Planning Application for Proposed Comprehensive Development Scheme to include Wetland Restoration Proposal and Proposed Filling of Ponds/Land and Excavation of Land in "OU(CDWRA)" Zone at Various Lots in D.D. 104, North of Kam Pok Road East, Pok Wai, Yuen Long, New Territories

Table A: Responses-to-Comments (12.5.2023)

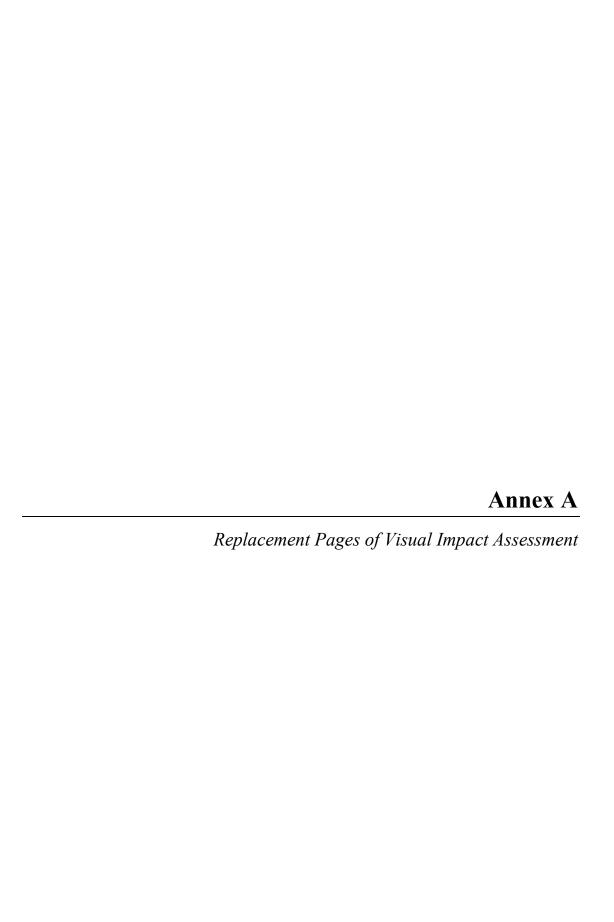
v.	The applicant is advised to clarify the 'area in brown color' proposed in the wetland area with proper legend.	Please note that the "area in brown color" represents Islands which provide foraging habitats for non-swimming water birds. Proper legend has been added in the Landscape Master Plans, dwg. no. LMP01 to LMP05 for reference (Annex B).
vi.	It is noted that there is no communal open space with recreational facilities proposed in the northern portion of the site for the enjoyment of residents. The applicant should consider to review the layout.	It is intended that the recreational facilities are concentrated at the amenity areas and roofs of clubhouses to the south of the Site. This will help to minimize the disturbance caused by human activities to the proposed WRA at the northern portion of the Site.
vii.	It is noted that tree planting is proposed on the roof-top gardens. The applicant should ensure the feasibility of tree planting in this early planning application stage.	As the clubhouses are only 2-storey high, it is considered that maintenance and replacement of the proposed trees is feasible. Besides, trees in small size when maturity, i.e. Osmanthus fragrans are proposed for the roof-top environment.
